PROJECT NO. SL 113-5-1

MINE DRAINAGE POLLUTION ABATEMENT
 COAL RUN
 SHAMOKIN CREEK WATERSHED
 NORTHUMBERLAND COUNTY, PA.

PLAN

DRAWN BY	DATE	DRAWING NO.
GMS	5-9-75	
CHECKED BY	SCALE	
DHC	1" = 100'	4 of 28

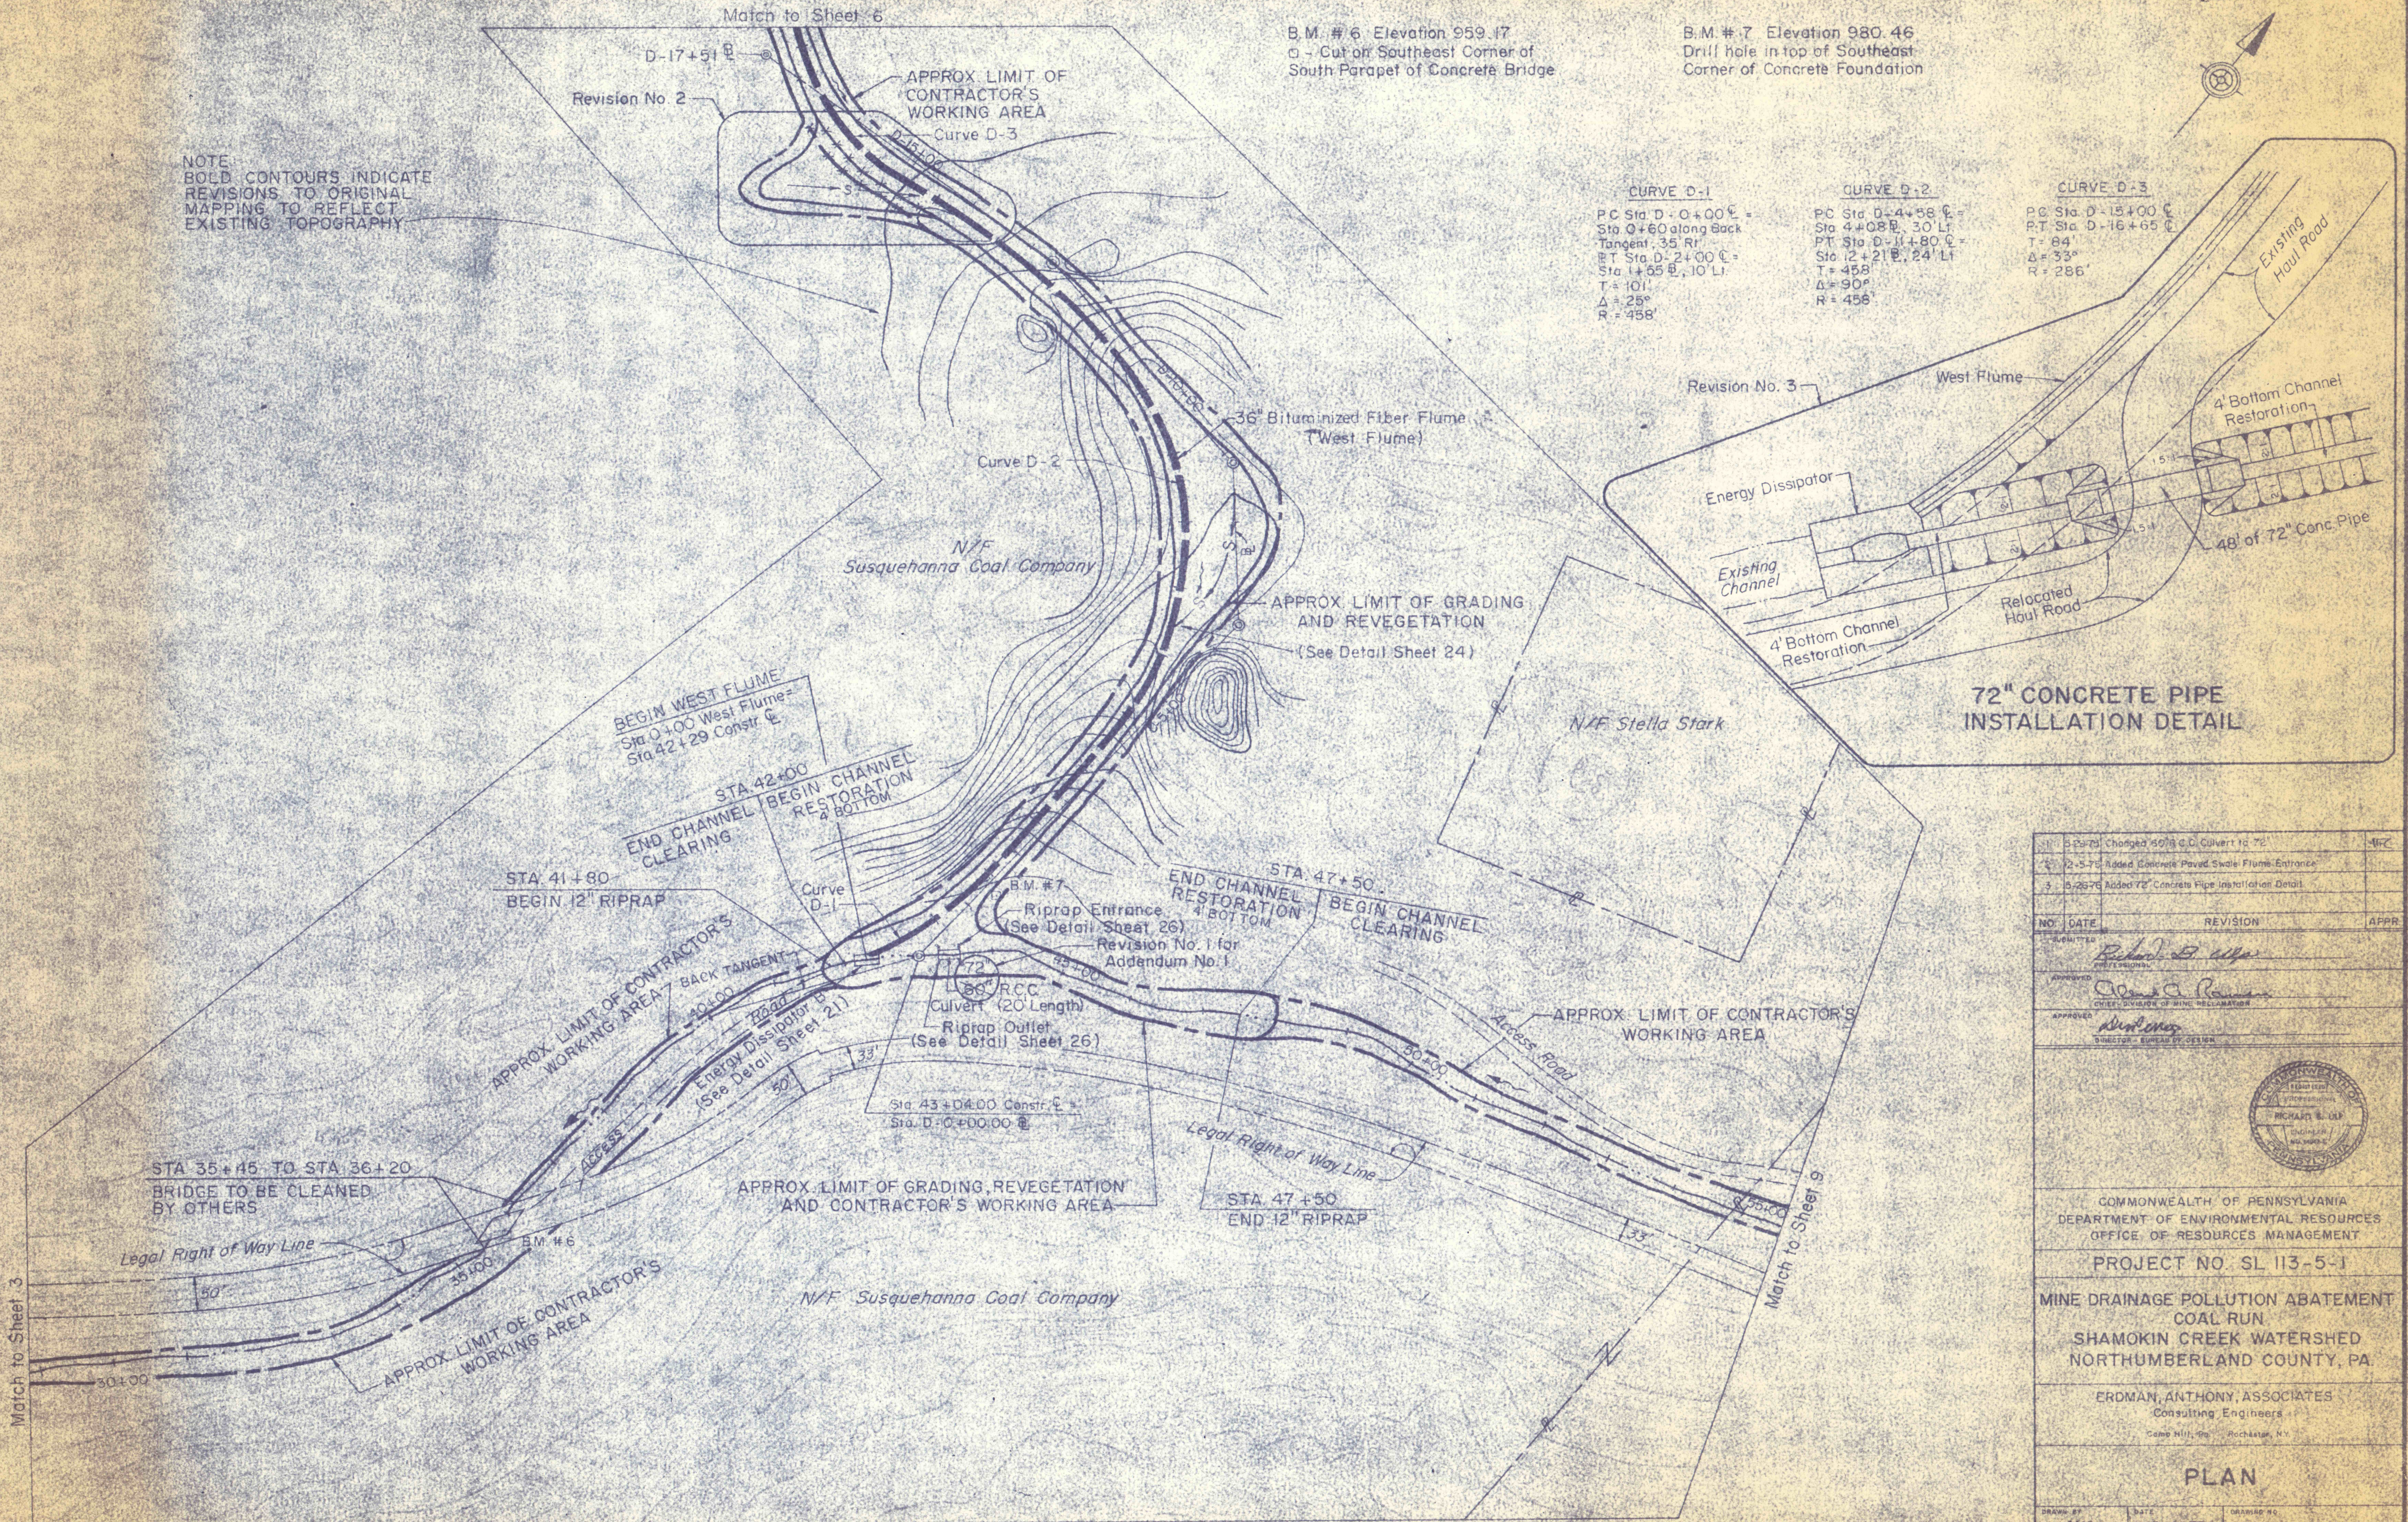
1	5-23-75	Changed 50" C.C. Culvert to 72"	-MFC
2	7-5-75	Added Concrete Paved Swale Flume Entrance	
3	10-26-75	Added 72" Concrete Pipe Installation Detail
